## SERVICE BULLETIN

**APPLICABILITY** 1990 THROUGH 1995 LEGACY 2.2L  
1992 THROUGH 1995 SVX 3.3L  
1995 IMPREZA 2.2L

**DATE** 10/11/95

**SUBJECT** KNOCK SENSOR

Revised SVX Service Manual Removal And Replacement Procedures For Knock Sensors Number 1 (RH) and Number 2 (LH). This information supersedes the Removal And Replacement Procedures listed in the SVX Service Manuals.

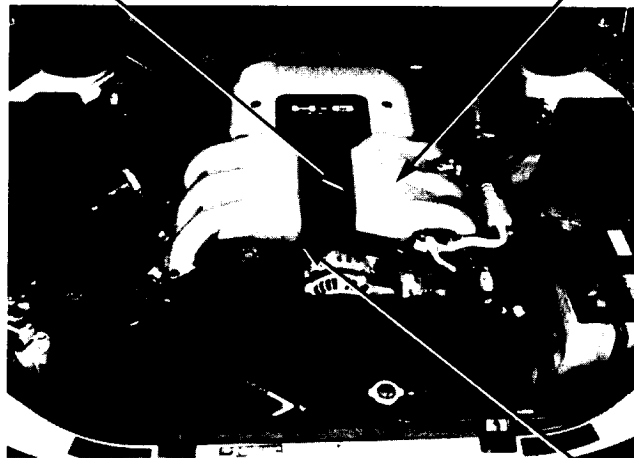
1. Disconnect the knock sensor wire connector.
2. Note the orientation of the knock sensor on the engine block and install the new sensor in the same position.
3. Use a 3/8 drive ratchet, 12 inch extension and a 12mm flex socket to access the knock sensor mounting bolt.
4. Insert the extension and socket assembly through the left side of the hole in the center of the intake manifold, refer to the illustration below.

**Note:** When removing the knock sensor, the wire connector is tight but will pass between the coolant crossover manifold and the engine block.

1. Disconnect the knock sensor wire connector.
2. Note the orientation of the knock sensor on the engine block and install the new sensor in the same position.
3. Use a 12mm boxed end wrench to access the knock sensor mounting bolt from the front of the engine.

**Note:** Torque the knock sensor mounting bolt(s) for all applicable models to 17.4 ± 2.1 ft-lb.
